Road Safety Audit Stage 2 (Supplementary)

Botley Bypass

Document reference: 09/246

4 Items raised at this supplementary Stage 2 Audit

Annotated Plan

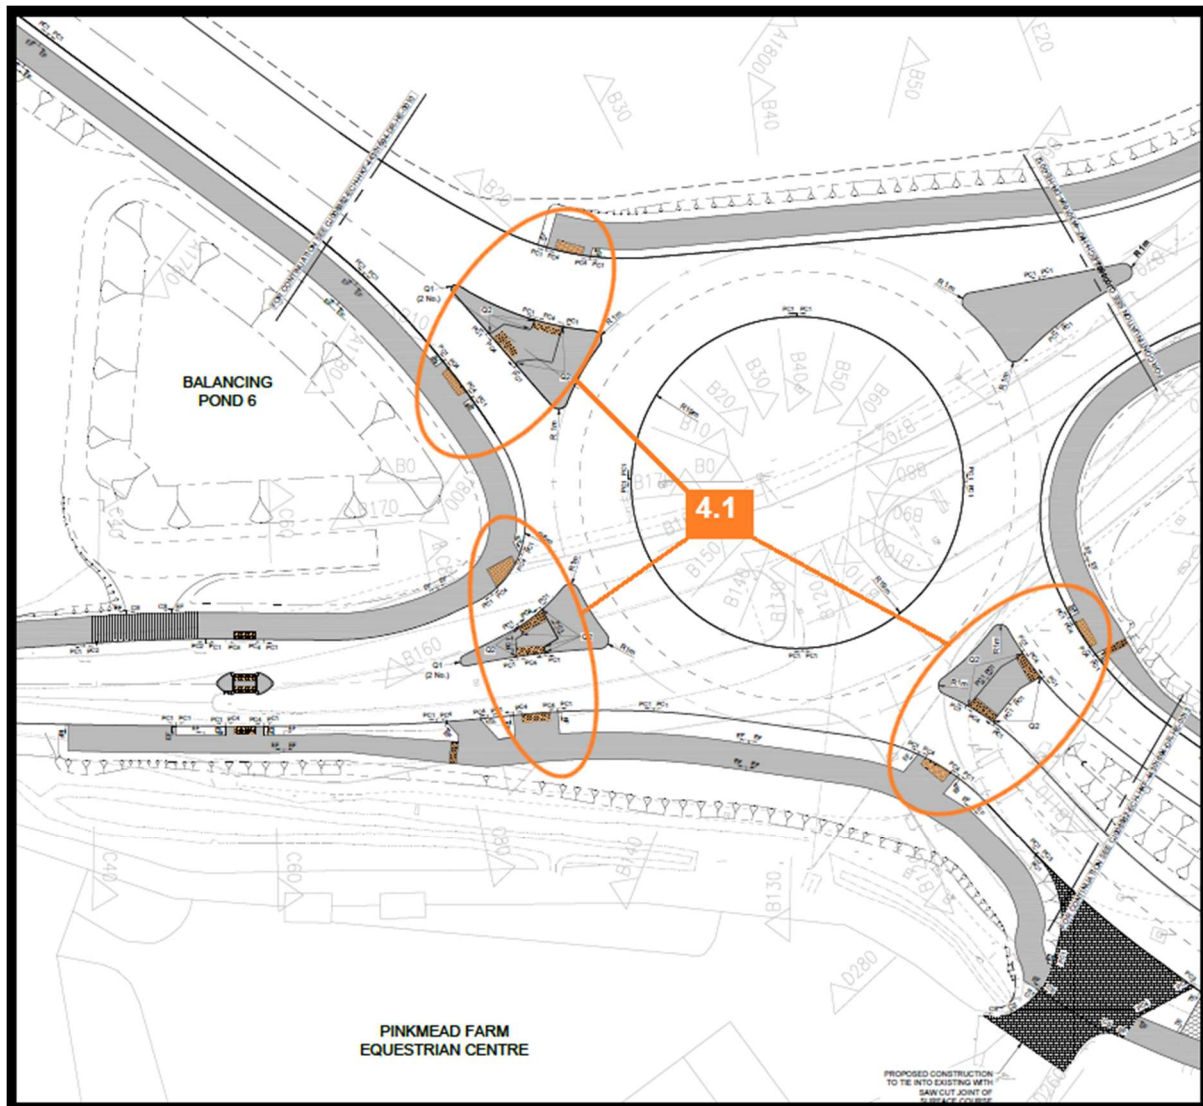
Location: All crossing points on Pinkmead roundabout.

Summary: Inadequate pedestrian crossing provision.

Pedestrians and cyclists may struggle to find suitable gaps in traffic, especially in peak times, when attempting to cross at the roundabout. Although crossing movements are likely to be low, there is still an increased risk of vehicle/pedestrian collisions at this location.

Recommendation: Assess forecasted traffic flow data on all arms of the roundabout to determine if uncontrolled crossings are acceptable or if a greater crossing provision is required.

Item No.	Problem Accepted (yes/no)	Recommendation Accepted (yes/no)	Designers Response
4.1	N	Y	See below for details.

The predicted two-way traffic flow using the bypass and Station Hill arms are 23,000 AADT. The previous design for the roundabout included a SLTL to prioritise traffic flows between the bypass and Station Hill. This would have created three separate movements for pedestrians and cyclists crossing at either end of the SLTL.

The current design removes the SLTL. The exit onto the bypass has been narrowed to a single lane, thereby reducing the distance for users to cross. There will be two lanes to cross at the bypass roundabout entry instead of a two-stage crossing of a single lane and the free-flow SLTL.

The uncontrolled crossings via the Station Hill splitter island have been removed and an additional refuge introduced approximately 60m northeast of the roundabout, which improves the desire line. The remaining crossings stay as previously proposed, with the Mill Hill being redesigned to incorporate a further pedestrian refuge to aid access to and from the bus stops and the 30mph speed limit extended from Botley village up to the roundabout.

Although the posted speed limit at the roundabout will be 40mph, the need for drivers to give way to those circulating, the relatively small size of the roundabout, the deflections achieved and smaller exit radii, drivers are likely to be approaching, manoeuvring and exiting at lower speeds making it easier and safer for users to cross.

As no predicted pedestrian and cycle flows are available, it is not possible undertake detailed assessments of crossing option types. Whilst predicted flows are unknown, flows to and from the station from Botley village and the North Whitely development are likely to be tidal, and low in numbers and are unlikely to meet the PV² assessment criteria to justify inclusion of controlled signal-controlled crossings.

Uncontrolled crossings are now only proposed across three of the four approaches, with a revised crossing provision proposed within Station Hill. Having addressed all problems raised in the RSA2, and incorporating additional suggestions from informal advice received, it is considered that the risks of including uncontrolled crossing facilities at the junction have been minimised.
